**Subject: Supplemental Submission for Baxter Road and Sconset Bluff Storm
Damage Prevention Project NOI (SE 048-2581)**

**SUPPLEMENTAL RESPONSES TO QUESTIONS FROM NANTUCKET CONSERVATION
COMMISSION ASKED AT PUBLIC HEARING ON AUGUST 8, 2013**

RESPONSES TO COMMENT LETTERS FROM MILONE & MACBROOM DATED AUGUST 2, 2013

PROPOSED SECTION A-A AT LOT 115

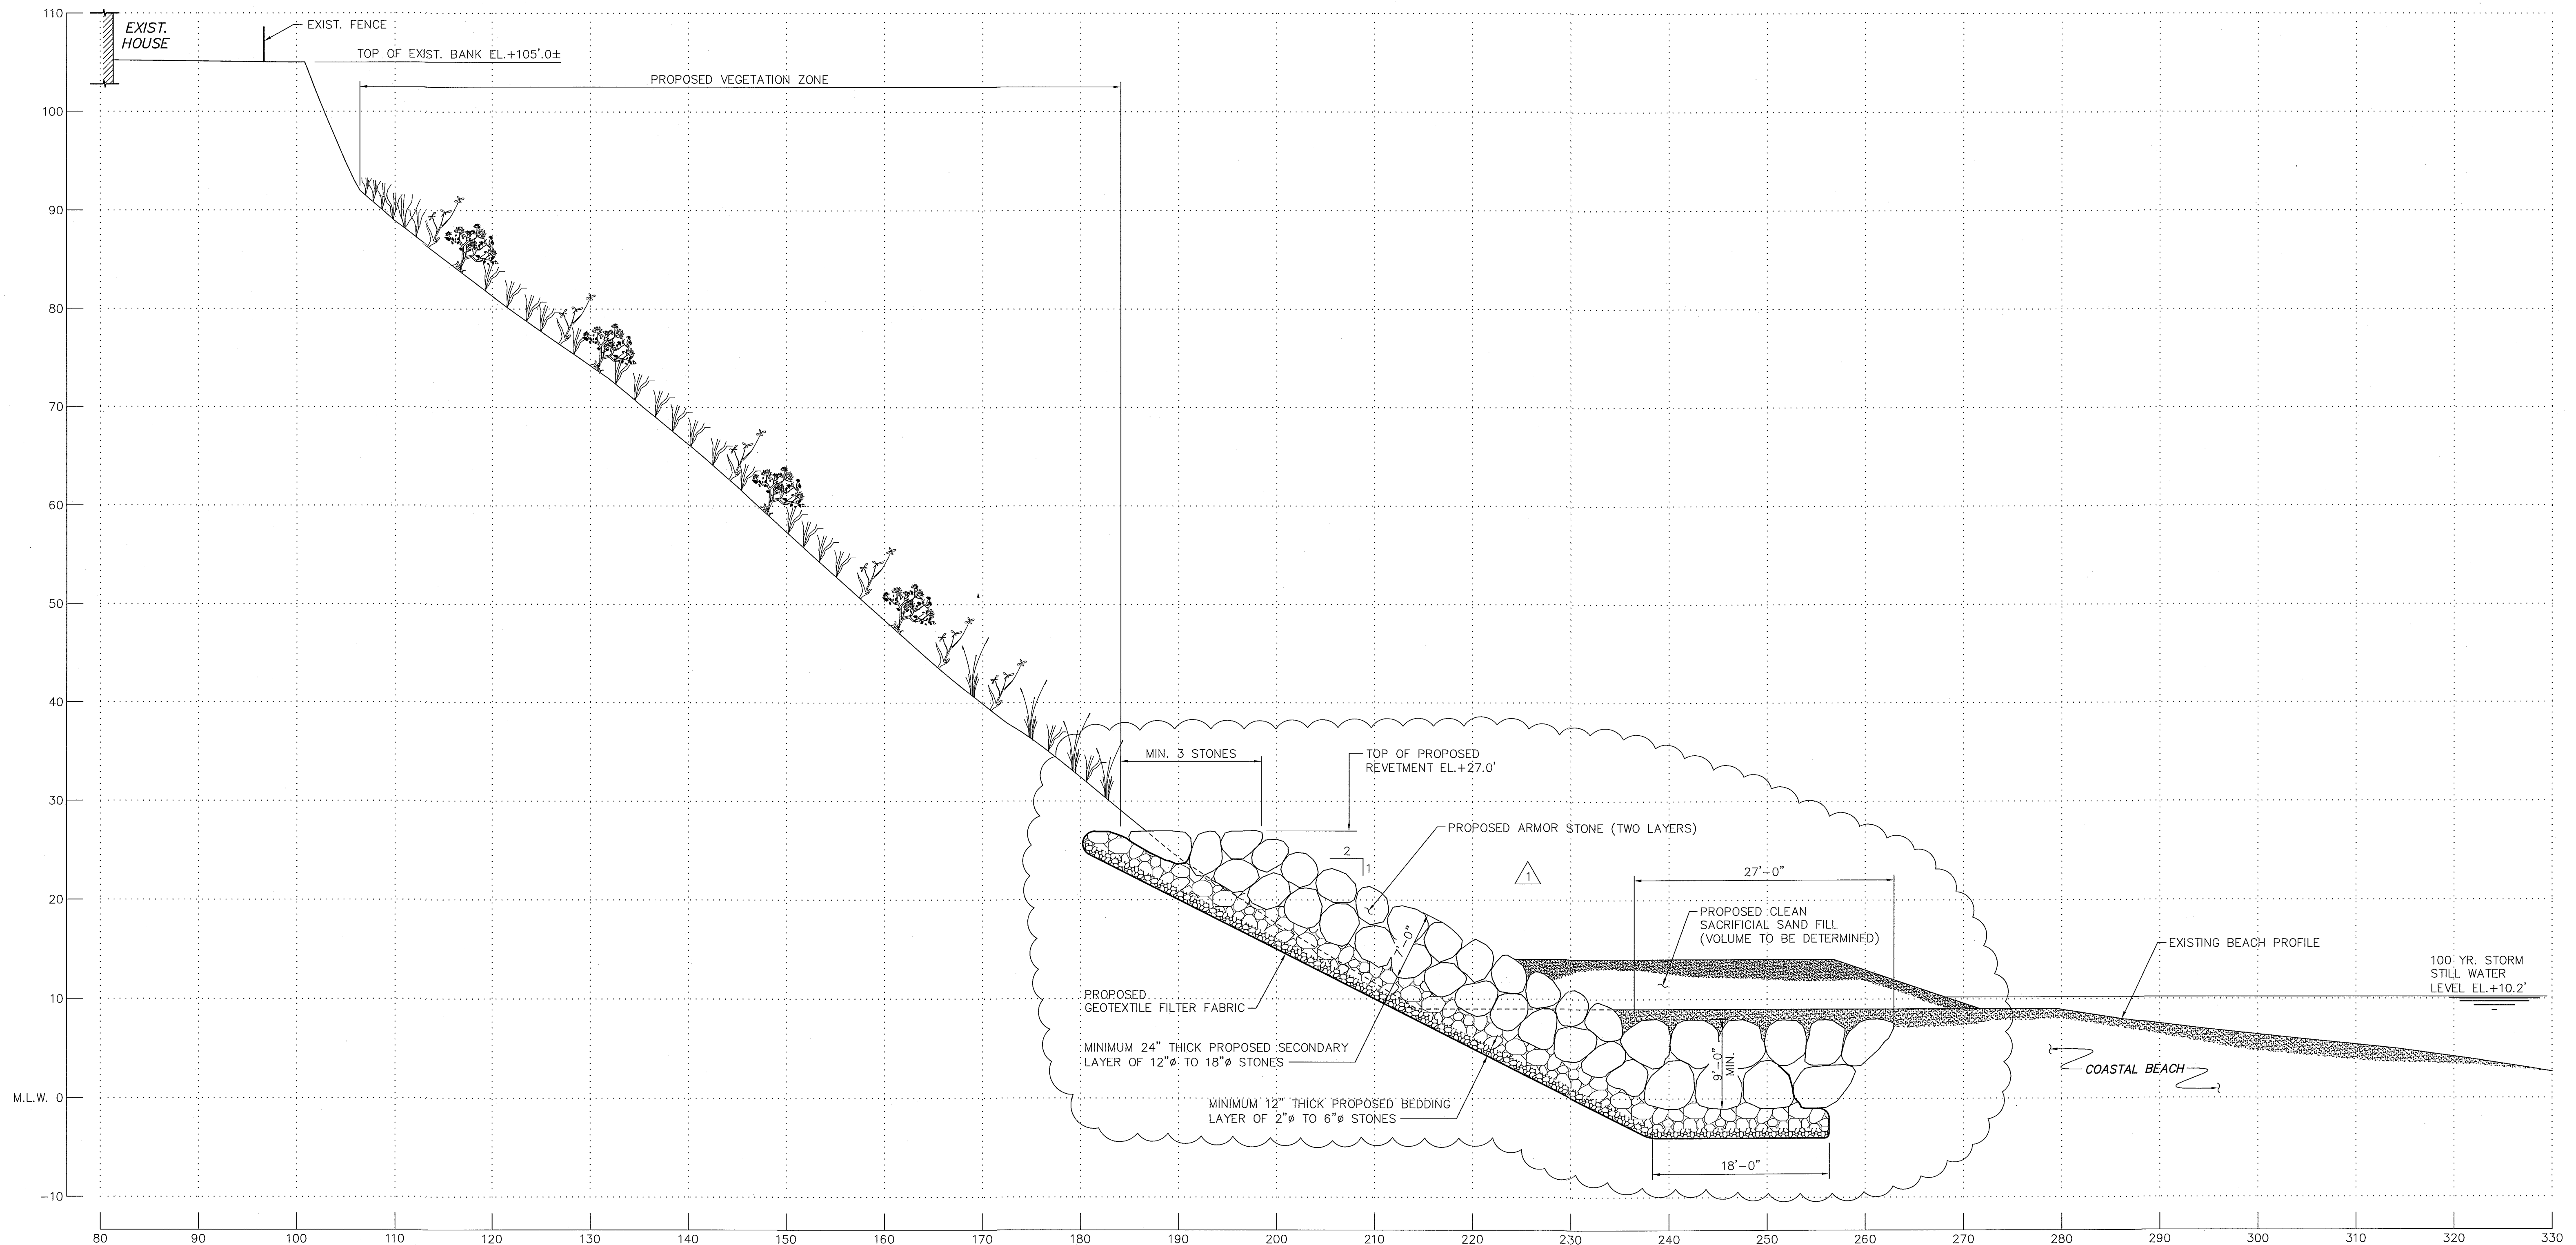
1. The plans were developed based on survey from 2010 and do not reflect existing site conditions. The existing bank in some areas is much steeper than is reflected on the plans. The steepness of the slope would not affect the type of stabilization proposed although there may be areas where the coastal bank is too steep to revegetate with regrading. It is not recommended that the finished revetment slope be any steeper than the proposed 1.5:1.

The plans presented are for permitting purposes only and are not intended to be suitable for construction. In our opinion, the construction documents should include cross sections of the revetment and slope improvements at 100-foot intervals to more fully detail the proposed activity..

Stamped plans based on an updated (2013) LIDAR survey were provided on August 15. A further revision to the plans is attached to this document, where the finished slope revetment has been changed to 2H:1V to increase the stability factor of safety for the coastal structure. While the 1.5H:1V slope is technically valid, the Applicant is proactively adopting a more conservative approach in response to concerns voiced during the previous hearings. Existing sections of bank that exceed this slope will require surface preparation (minor cutting and/or filling) to achieve this maximum slope, as shown on the cross sections of the attached plans.

The updated plans provide a total of seven (7) sections for the shorter revised Project area, these represent four (4) additional cross-sections than the original NOI submission. OCC

Figure 1
Coastal Bank Retreat

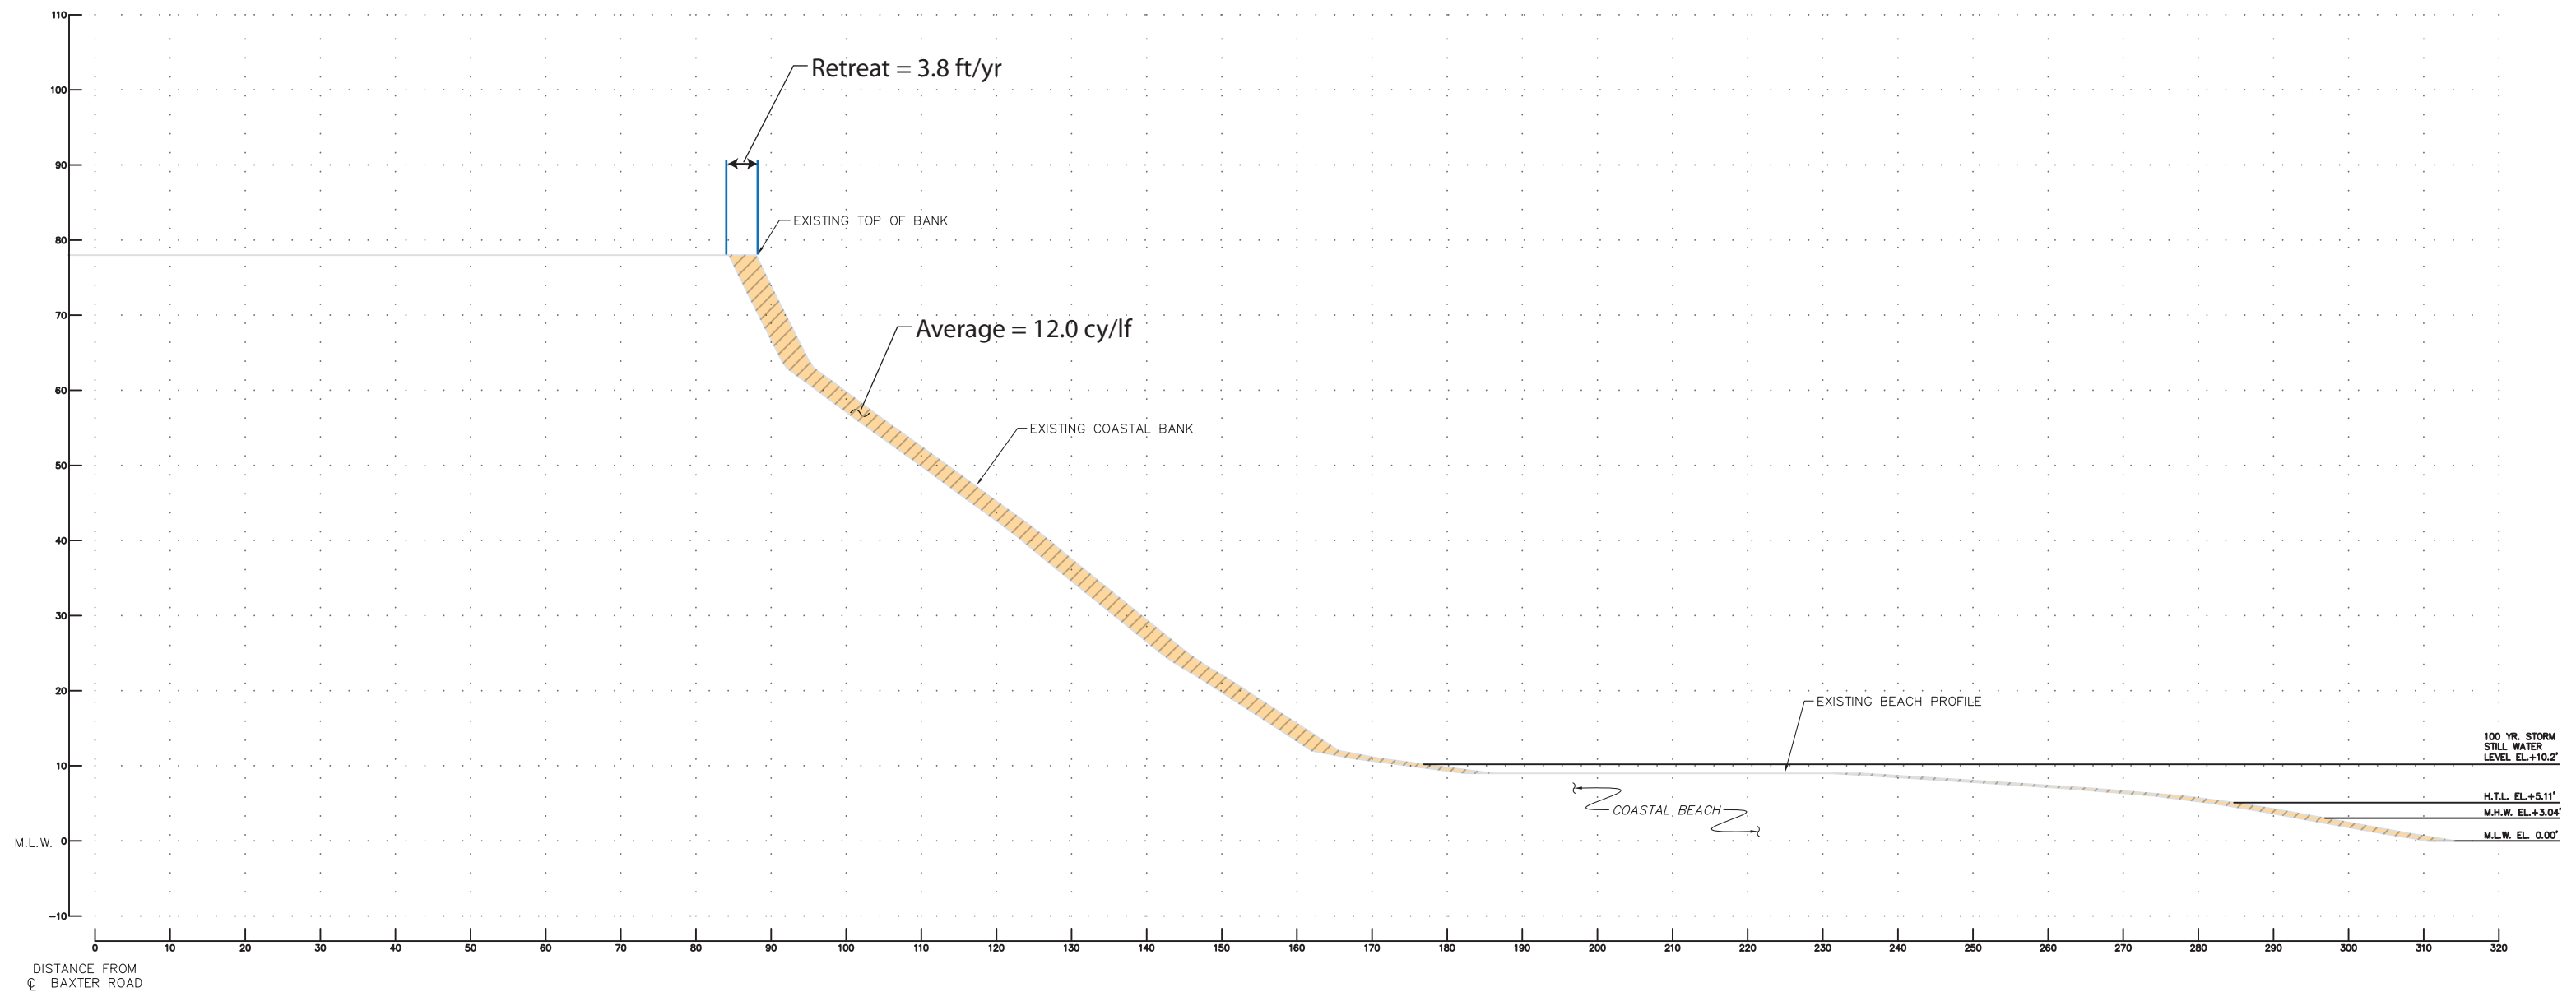
Provide an updated bank contribution volume using the 2013 LIDAR data.

- **Bank Retreat Rate.** The top of the coastal bank was digitized for 1994, 2003, and 2013 using ESRI ArcGIS software to produce the attached figure (see Figure 1). Top of coastal bank retreat was analyzed along shore-perpendicular transects spaced approximately every 20 feet.
 - For the portions of the project area from 91-119 Baxter Road, the top of coastal bank was actively retreating as early as 1994. For these lots, a long-term (1994-2013) coastal bank retreat rate of **3.2 feet/yr** was calculated.

- For the portions of the project area from 71-91 Baxter Road, the top of coastal bank was not actively retreating in 1994 (Figure 1 shows that the 1994 and 2003 top of bank lines are coincident south of 91 Baxter Road). For these lots, a 10-year (2003-2013) bank retreat rate of **4.5 feet/yr** was calculated. (Note: 79 Baxter Road was excluded from these calculations due to the presence of the terraces during much of this time period.)

- **Volume Calculation:** Section views from each of the Project lots from 63-119 Baxter Road were developed from the 2013 LIDAR survey. The volume associated with a bank retreat of 3.8 ft/yr was then determined for each lot using AutoCAD (see typical Figure 2). An average volume for all the project lots was then determined, yielding **12.0 cubic yards/linear foot/year (cy/lf/yr)**.
